## **Town of Arlington, MA Redevelopment Board**

### **Agenda & Meeting Notice July 22, 2019**

#### **1. Environmental Design Review, 1207-1211 Massachusetts Avenue, Arlington, MA - Docket #3602 Public Hearing**

# SPECIAL PERMIT - SITE PLAN REVIEW

6:00 PM

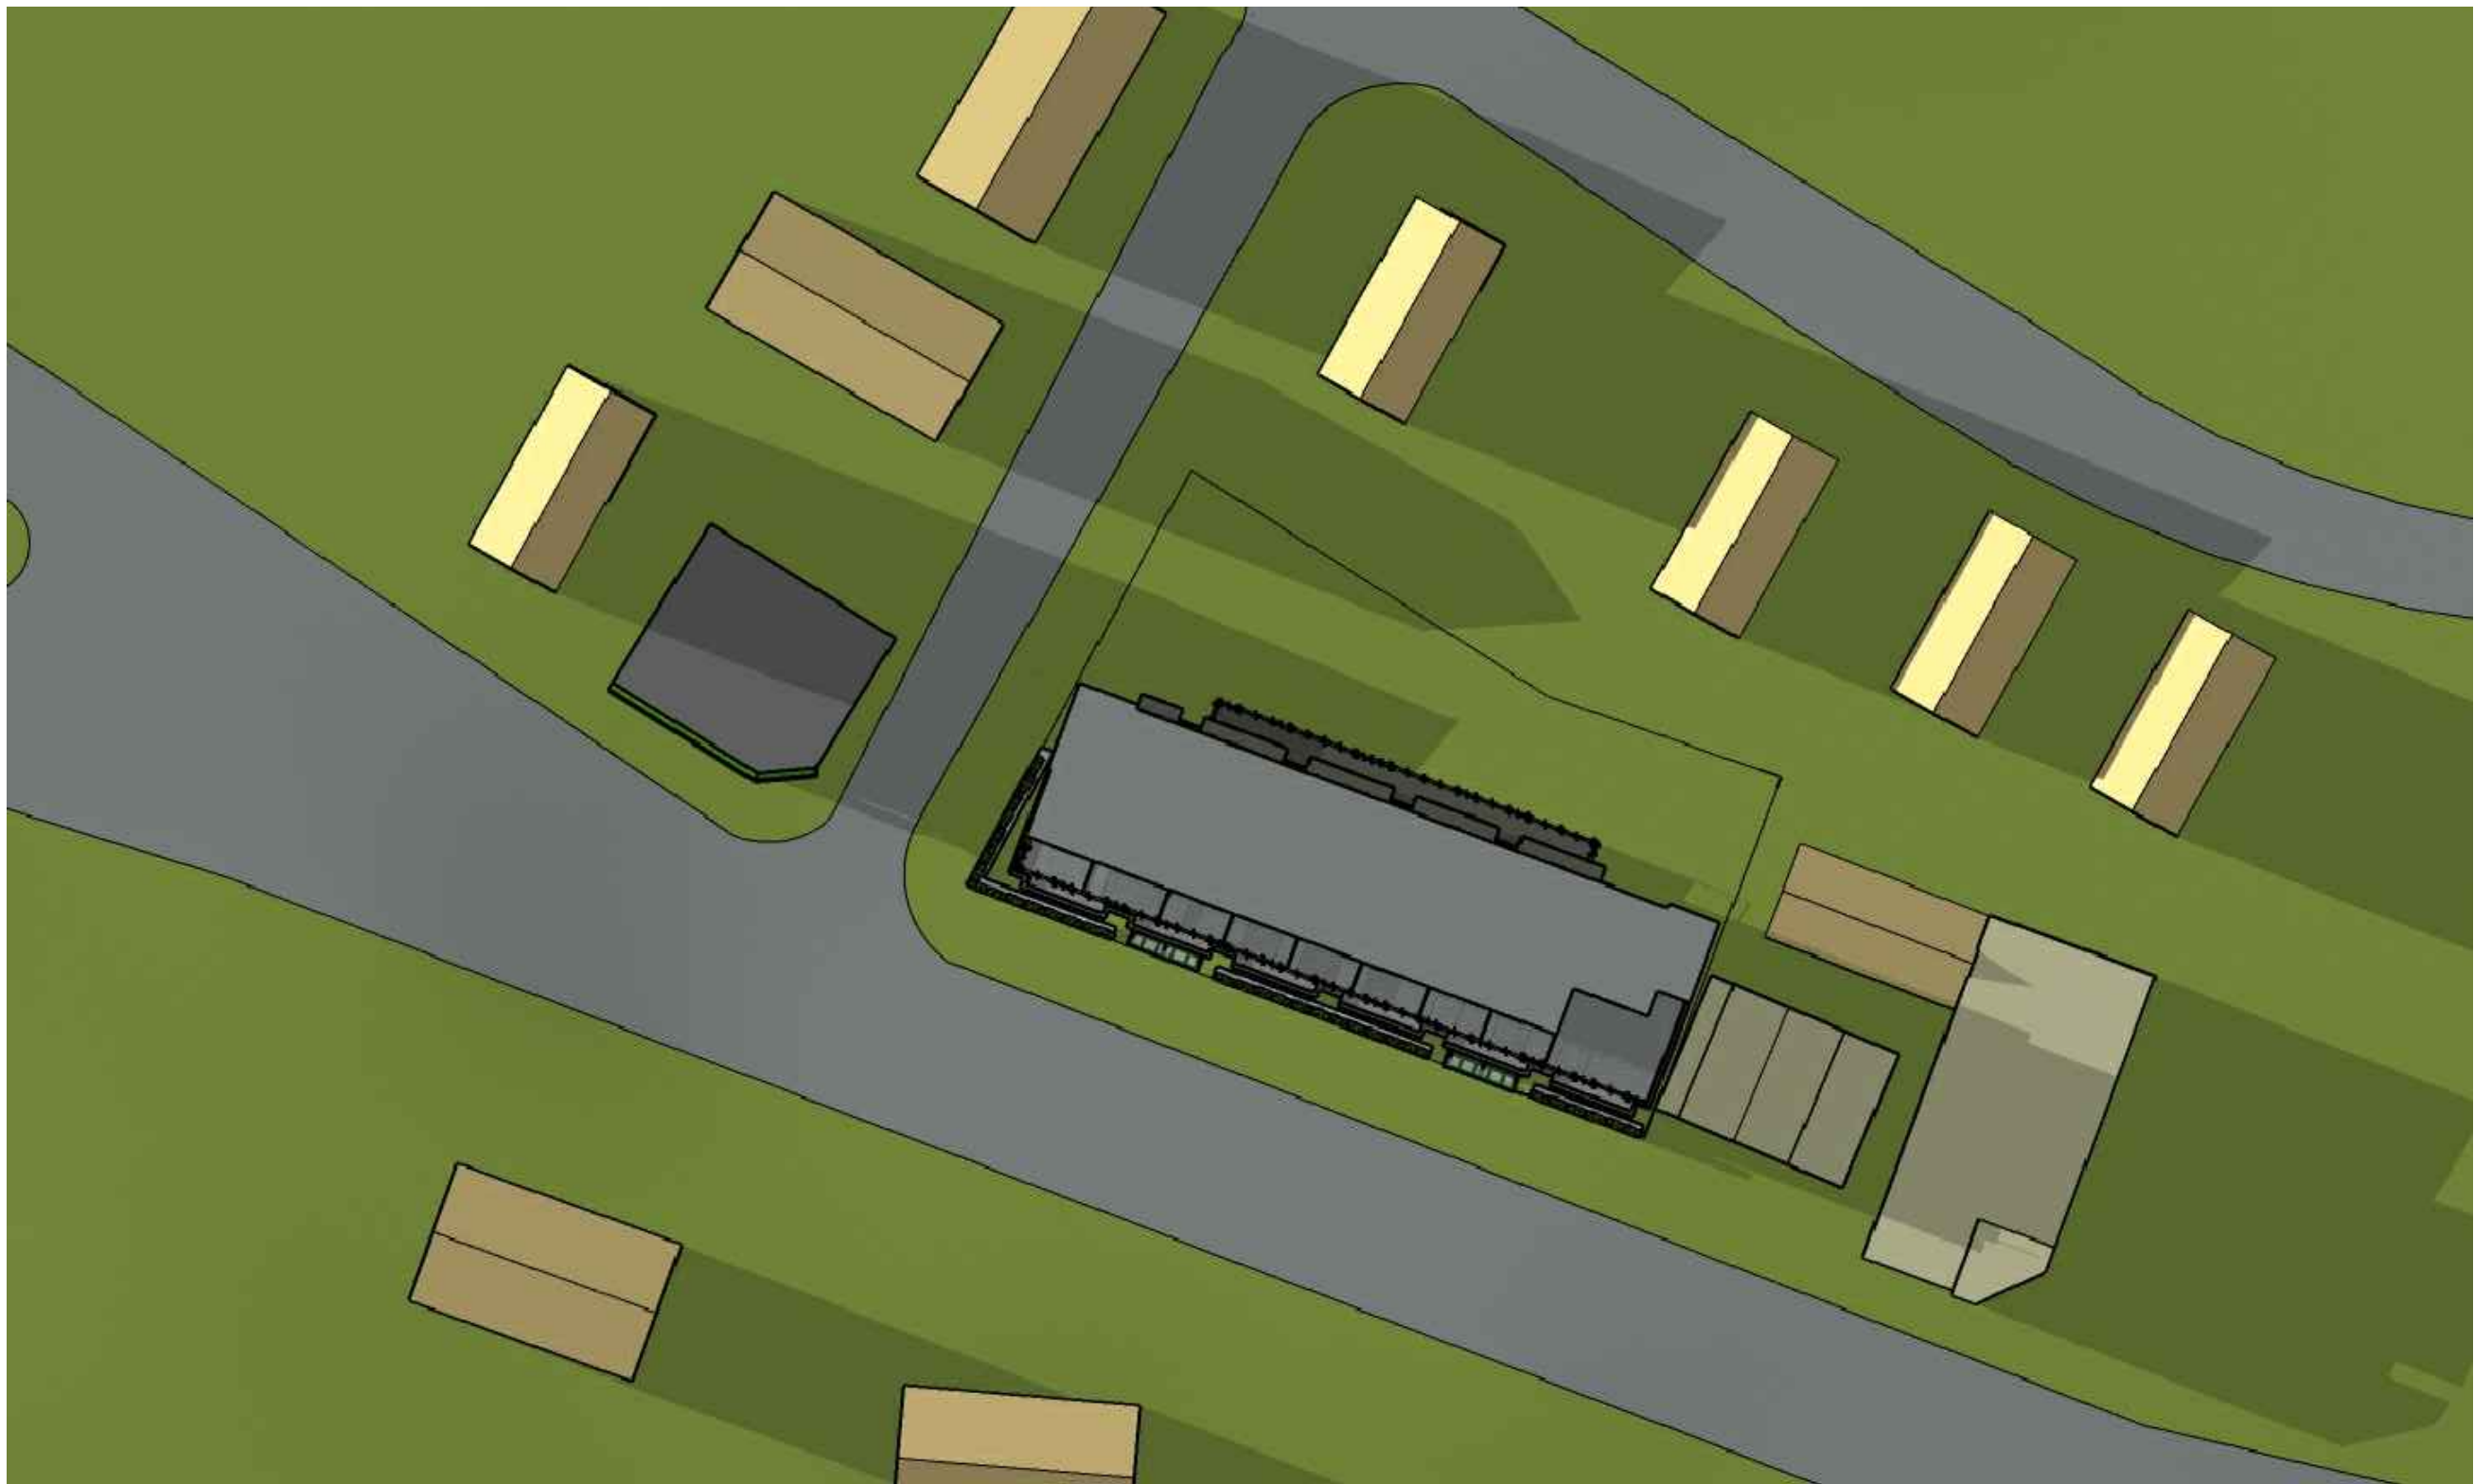
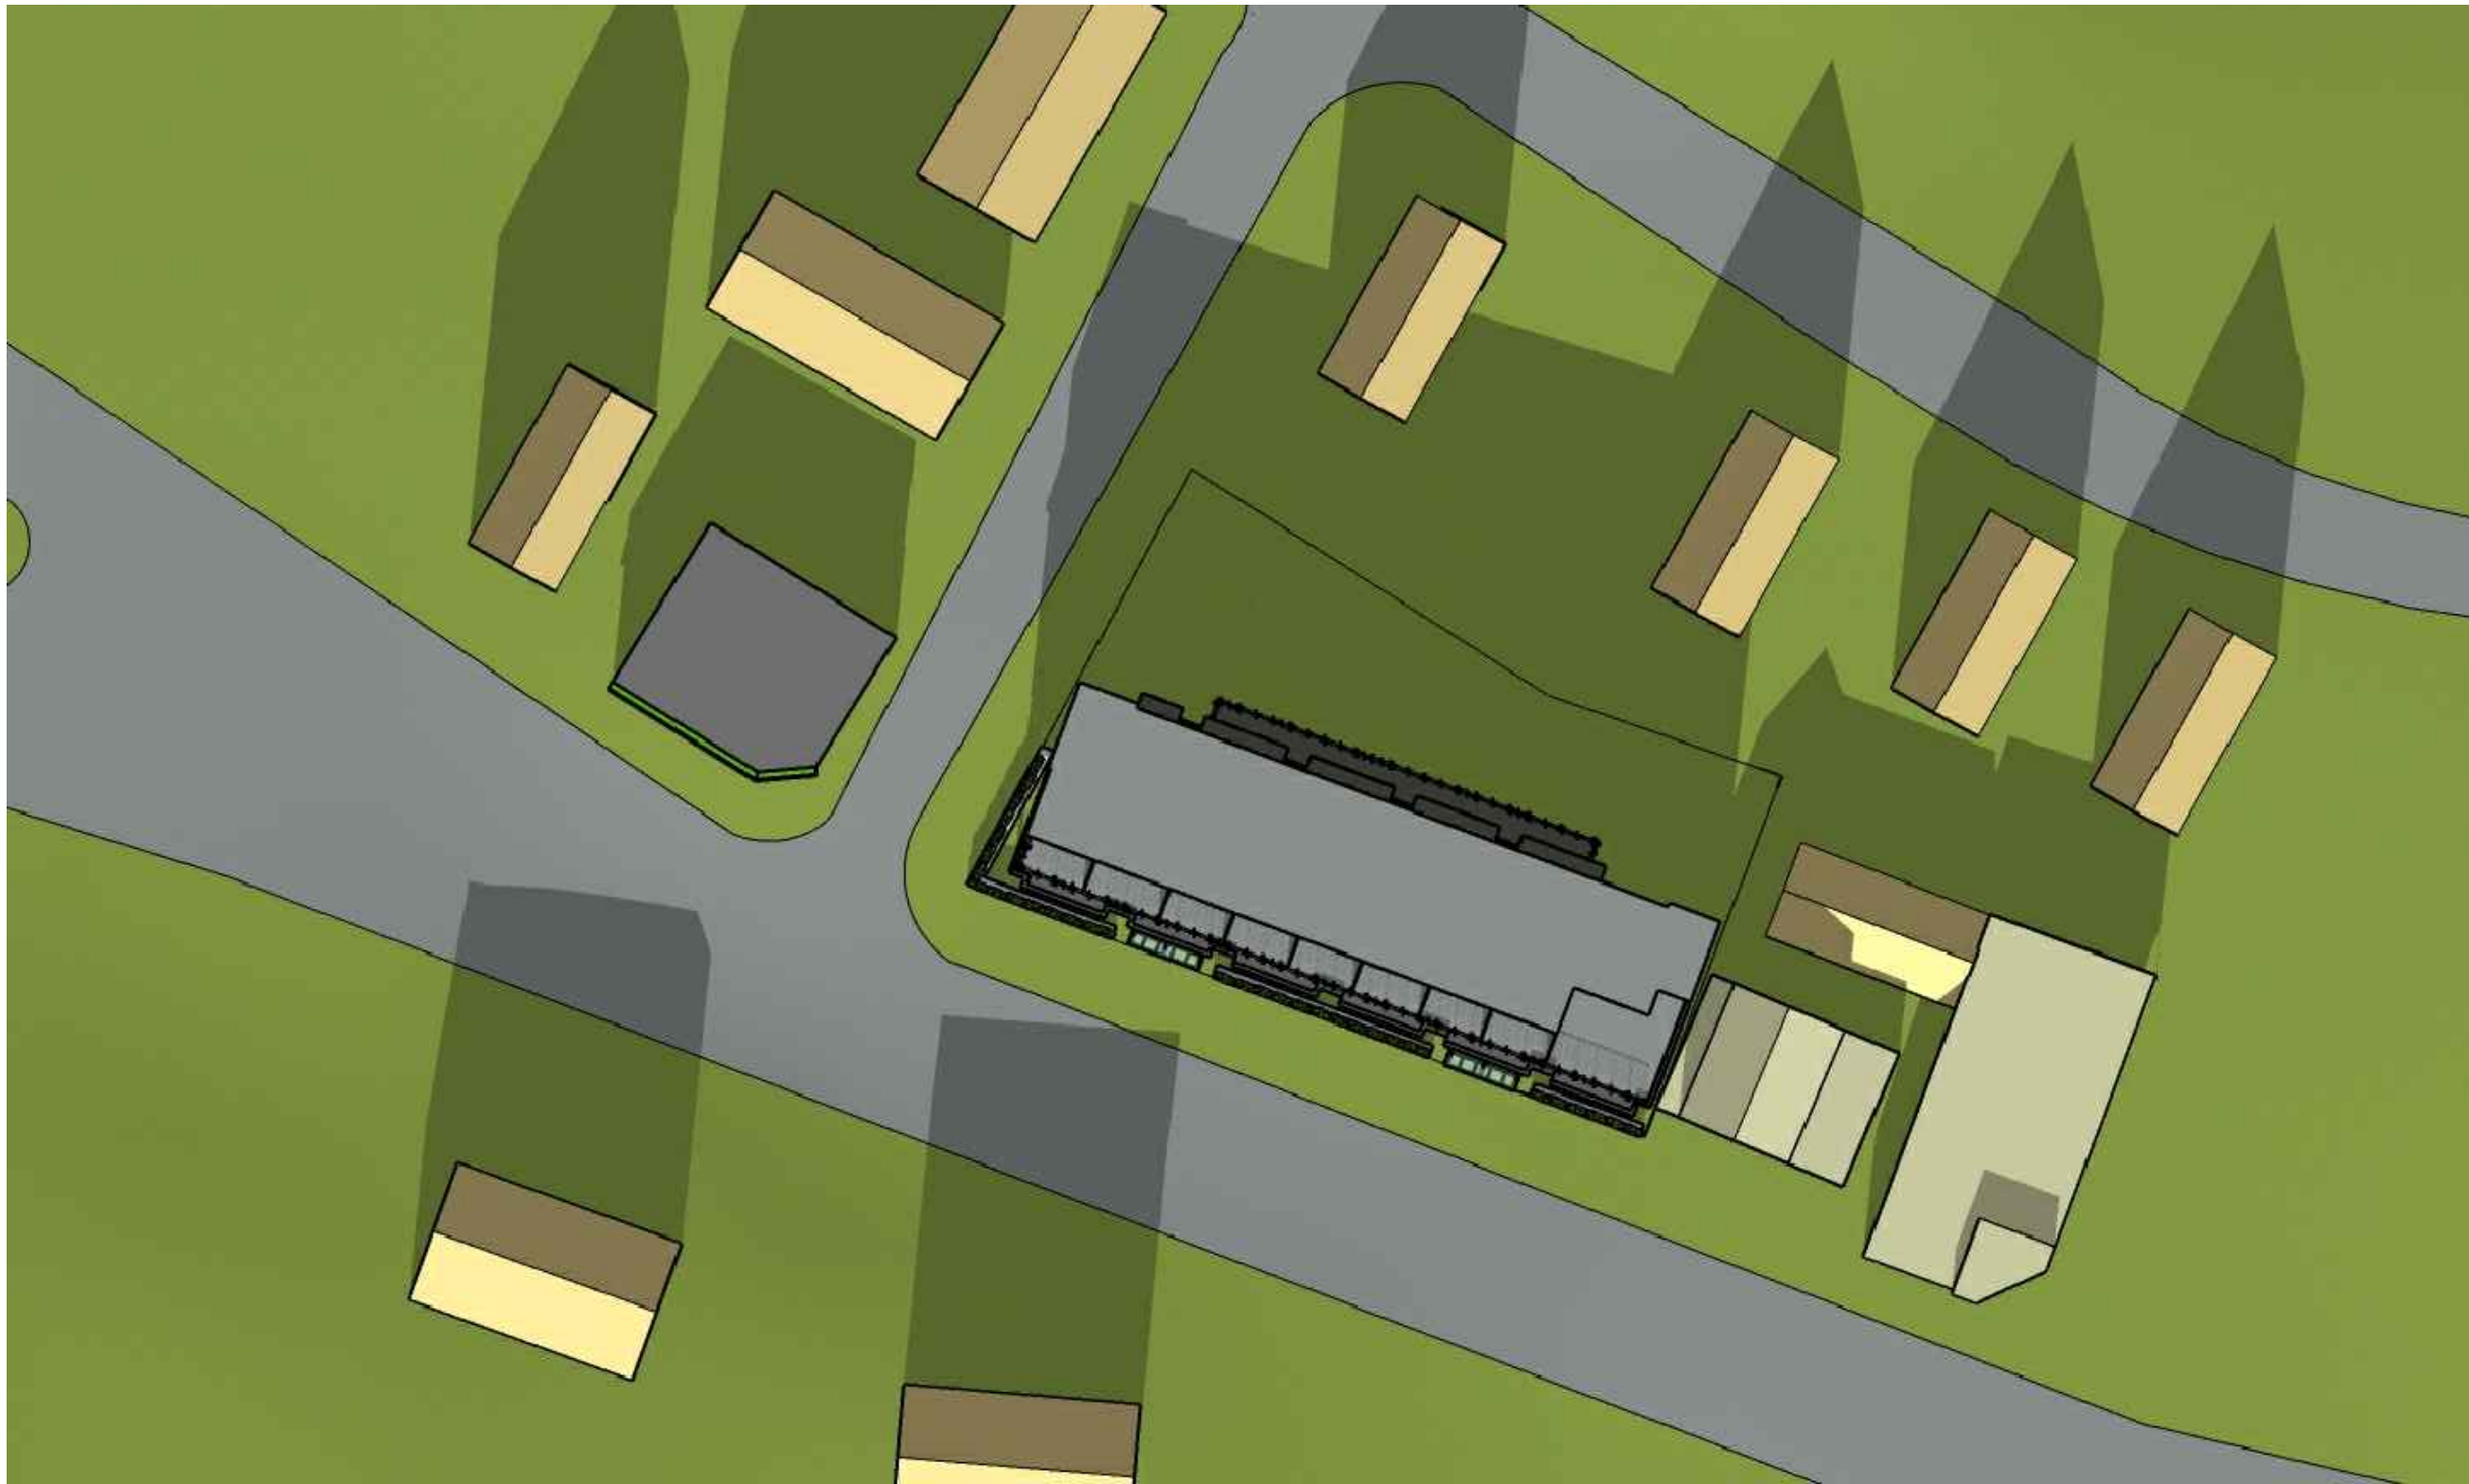
The building does not trigger the height buffer area of Section 5.3.19 because it is proposed at the lower maximum stories and height as identified in the Table of Dimensional and Density Requirements for the Business Districts. However, the application materials also provide a shadow study during each season at the respective Solstice and Equinox.

The proposed changes do not appear to significantly affect the immediate microclimate, however, the height of the new building may create shadows on adjacent residences, and the proximity of Mill Brook should raise questions about additional stormwater inputs and flooding impacts.
